## PRODUCT CHANGE NOTICE

**AN-80-008**

ORIGINAL PART: RSW-2-25P+  
 REPLACEMENT PART: RSW-2-25PA+

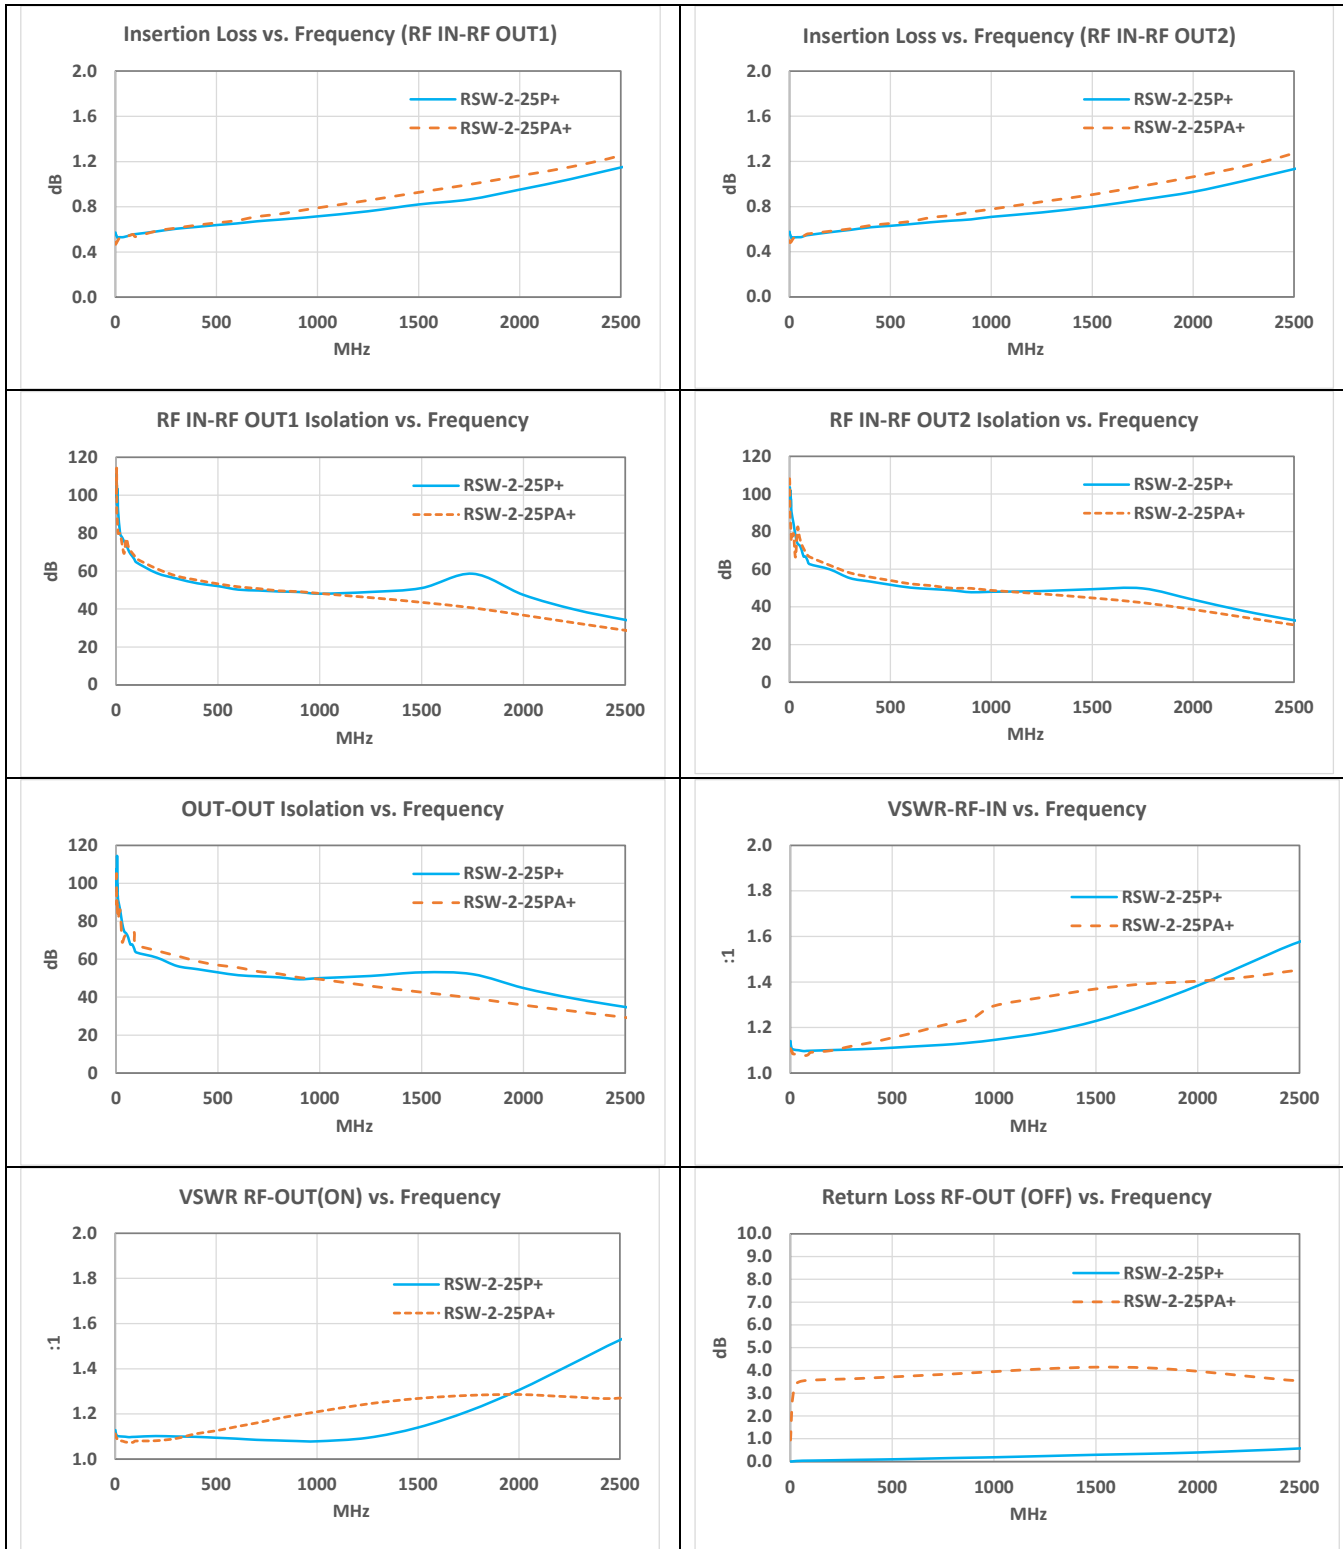
*This replacement part has been judged by Mini-Circuits Engineering as a suitable replacement part for the existing RSW-2-25P+. As a result of die obsolescence of the original design, the re-design effort includes the use of the new die in package mounted on an interface PC board to enable functional replacement while maintaining existing PCB footprint.*

<p><b>ORIGINAL PART: RSW-2-25P+</b> APPLICATION CIRCUIT</p> 	<p><b>REPLACEMENT PART: RSW-2-25PA+</b> APPLICATION CIRCUIT-No Change</p> 
<p><b>ORIGINAL PART: RSW-2-25P+</b> CASE STYLE: CL620</p> 	<p><b>REPLACEMENT PART: RSW-2-25PA+</b> CASE STYLE: CL620-1 (6 x 8.7x1.8 mm <b>(FOOT PRINT COMPATIBLE)</b>)</p>

- 1) **FORM-FIT-FUNCTIONAL COMPATIBLE:** Similar Circuit and PCB Layout.
- 2) **TYPICAL PERFORMANCE COMPARISON** <sup>a</sup>:
